**Amendments to the Drawings**

ANTI-ROTATION DEACTIVATION

VALVE LIFTER

Docket No.: 89190.115003/DP-311086

FIG. 3

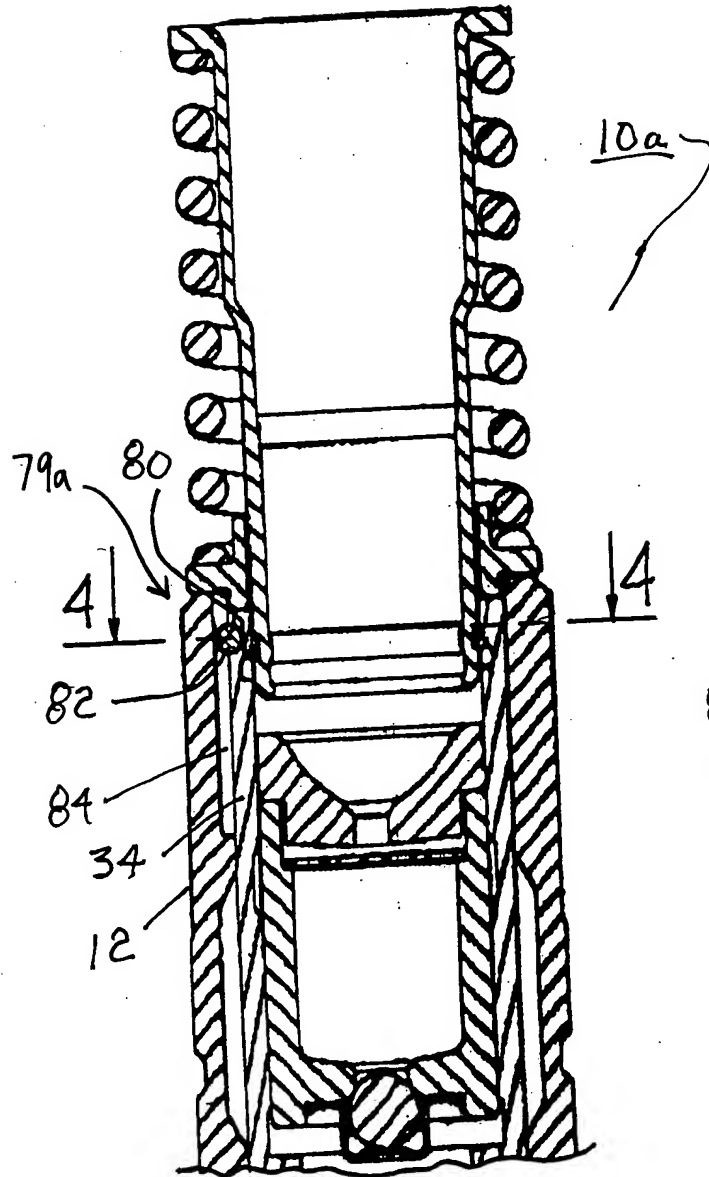
The drawings in the present patent application have been amended to make the specification and the drawings consistent with one another. In particular, Figures 3, 5, 6 and 7 have been amended to add reference numerals 79a, 79b, 79c and 79d, respectively, to make reference to the clocking mechanisms in the present invention. See *Specification*, pg. 7, lines 6, 24; pg. 8, lines 6, 15. In addition, Figure 7 has been amended to include reference numerals 81 and 83 to reference to the tang and spring clip. See *Specification*, pg. 8, lines 19, 22. Applicants submit herewith drawings labeled "Annotated Sheets Showing Changes" that show the proposed drawing amendments. Further, Applicants submit herewith Replacement Sheets that are intended to formalize Figures 1-7 and incorporate the above-referenced proposed drawing amendments into the drawings. Applicants respectfully request that the drawing amendments be entered.

Each of the attached sheets of drawings labeled "Annotated Sheet Showing Changes" shows the proposed changes to Figures 3, 5, 6 and 7. Each of the attached drawings labeled "Replacement Sheet" include the changes to Figures 3, 5, 6 and 7 and represent a formalized version of Figures 1-7.
